PSE&G Public Service
Electric and Gas
Company

August 10, 1984

HOPE CREEK GENERATING STATION
DOCKET NO. 50-354
DRAFT SAFETY EVALUATION REPORT
OPEN ITEM STATUS

Attachment 1 is a current list which provides a status of the open items identified in Section 1.7 of the Draft Safety Evaluation Report (SER). Items identified as "complete" are those for which PSE&G has provided responses and no confirmation of status has been received from the staff. We will consider these items closed unless notified otherwise. In order to permit timely resolution of items identified as "complete" which may not be resolved to the staff's satisfaction, please provide a specific description of the issue which remains to be resolved.

FIGURE A-16-6

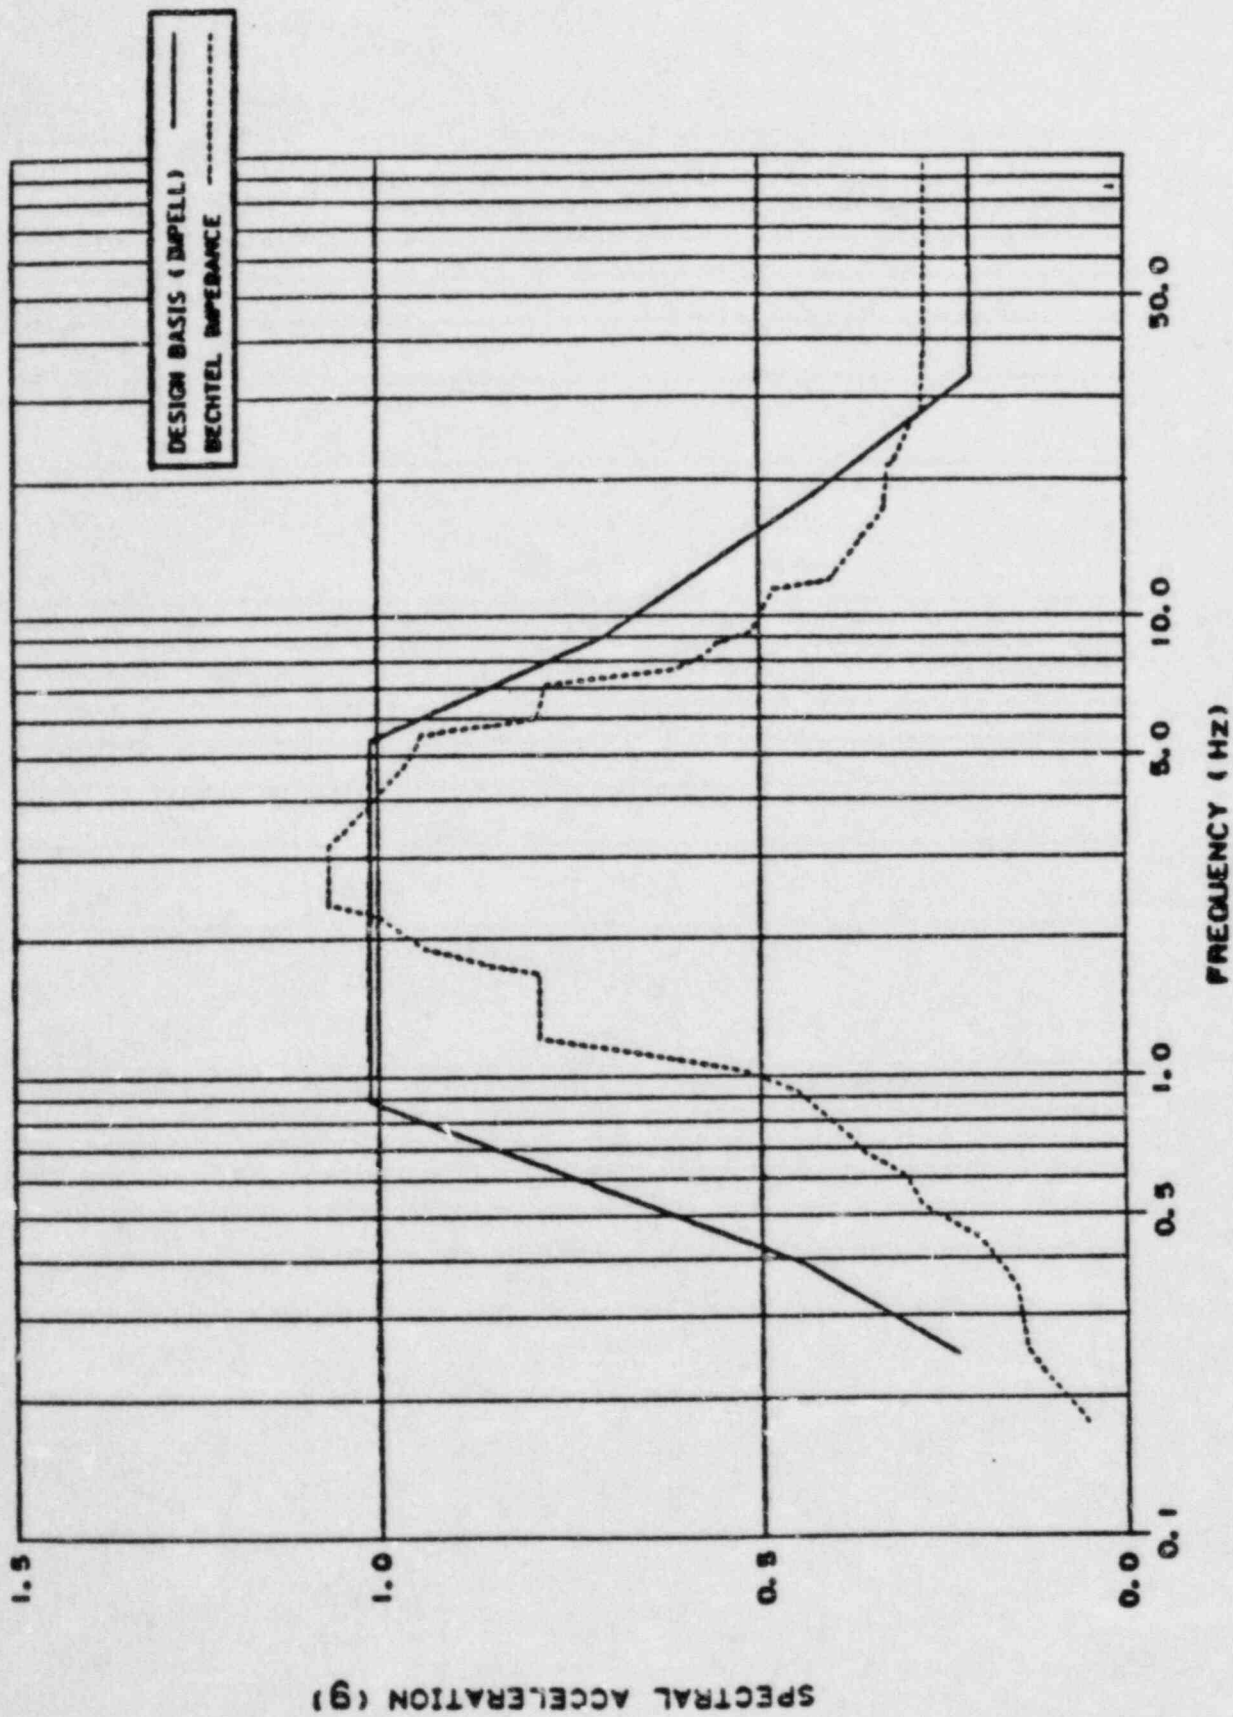
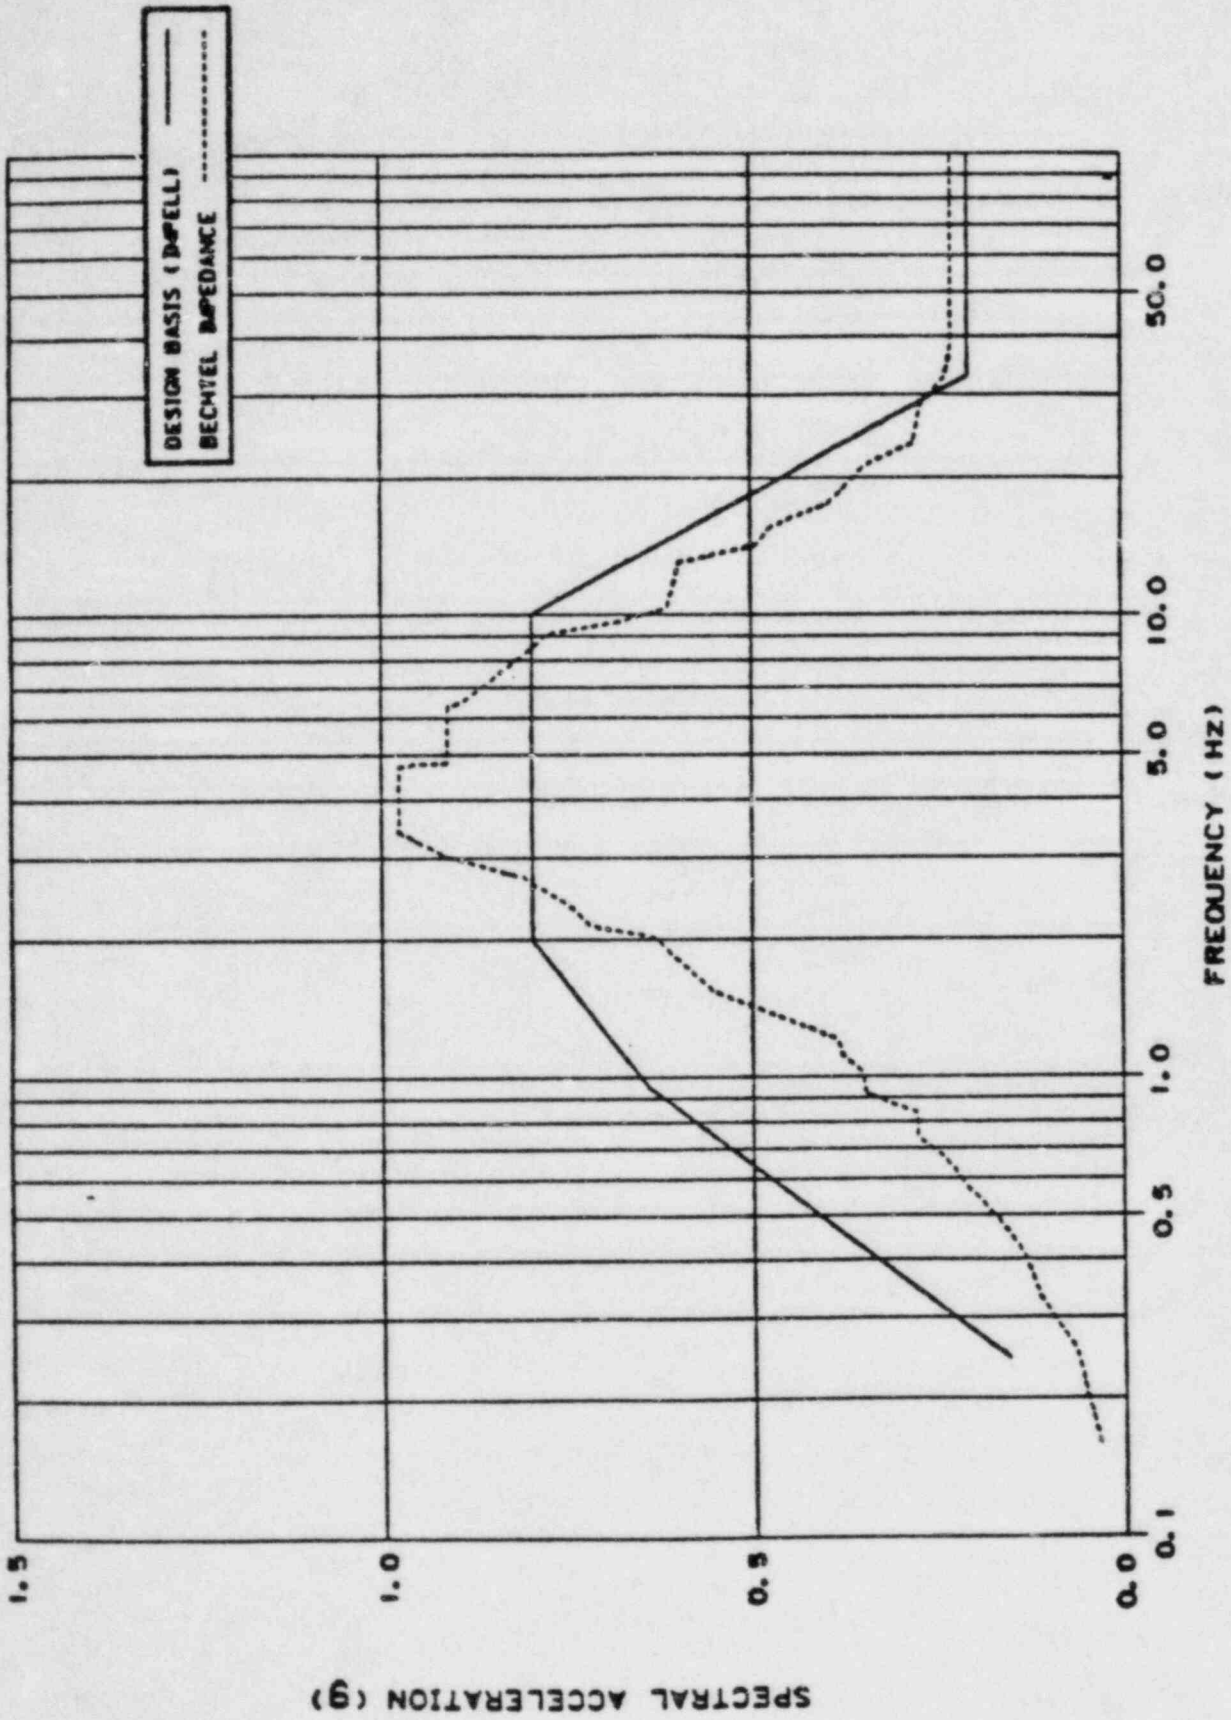
Question: Perform an independent seismic verification analysis (impedance analysis) for the intake structure and compare the results with design basis results. Consider the effects of side boundaries, embedment and the presence of water masses in the analysis.

Figures A-16-1 to A-16-18 show the comparison of the 2 percent damping response spectra obtained from the design basis finite element and the impedance approach seismic soil-structure interaction analyses. The impedance approach response spectra generally are enveloped by those obtained from the design basis analyses at elevation 114.0 feet of the SWIS. For other elevations, the impedance approach spectral accelerations exceed the design basis spectral accelerations in some frequency ranges. These ranges vary approximately between 1.5 and 10.0 Hz.
